Product Change Notice (PCN)

PCN Number: PCN-0210042R-01

Product(s) Affected: MSIM-3-C

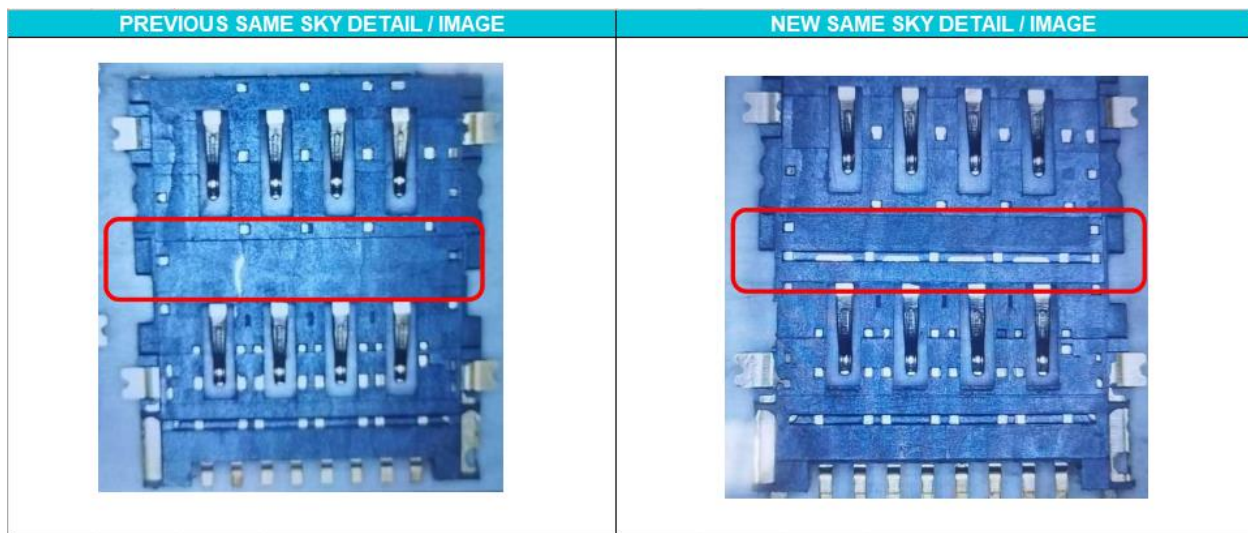
Description of Change: Pressure relief holes have been added to the bottom of the product. This addresses irregular terminal protrusion, ensuring a uniform and consistent product appearance, effectively reducing defects in the injection molding process.

Dimensions remain unchanged; this modification does not affect the product's functionality.
